In the Matter of the Application of)	Application No. 07-04-028
SOUTHERN CALIFORNIA EDISON)	
COMPANY (U338E) for a Permit to)	(Filed April 30, 2007)
Construct Electrical Facilities with Voltages)	
between 50 kV and 200 kV:)	
Fogarty Substation Project)	
_____)

SOUTHERN CALIFORNIA EDISON COMPANY (U 338-E)
PETITION FOR MODIFICATION OF DECISION 10-08-009

**SOUTHERN CALIFORNIA EDISON COMPANY, FOGARTY SUBSTATION,
PROJECT MODIFICATION REPORT**

Figure 2-1: Proposed Fogarty Substation Site Map Valley-Ivyglen 115 kV Subtransmission Line Project

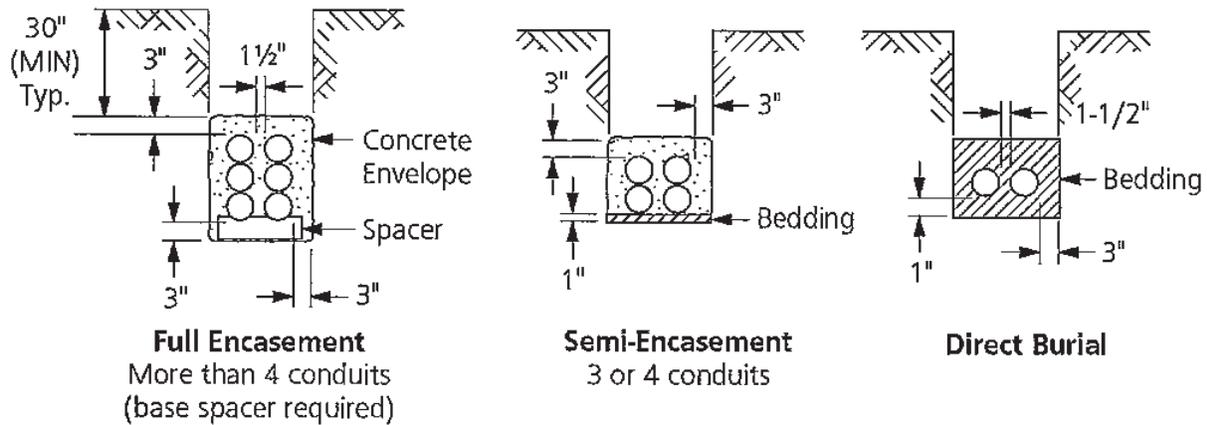
For the activities covered by the Proposed Modifications, the total length of the two distribution duct banks would be approximately 900 feet. The trenches would be approximately 2 feet wide and 5 feet deep with a 25-foot-wide work area centered on the trench. One vault would be approximately 7 feet wide, 14 feet long, and 8 feet deep, requiring an excavation pit that is approximately 9 feet wide, 16 feet long, and 10.5 feet deep. The other vault would be approximately 7 feet wide, 18 feet long, and 8 feet deep, requiring an excavation pit that is approximately 9 feet wide, 20 feet long, and 10.5 feet deep. Typical drawings for the distribution duct bank encasement and vault are provided in *Figure 2-2: Distribution Duct Bank Encasement Typical Drawing* and *Figure 2-3: Vault Typical Drawing*.
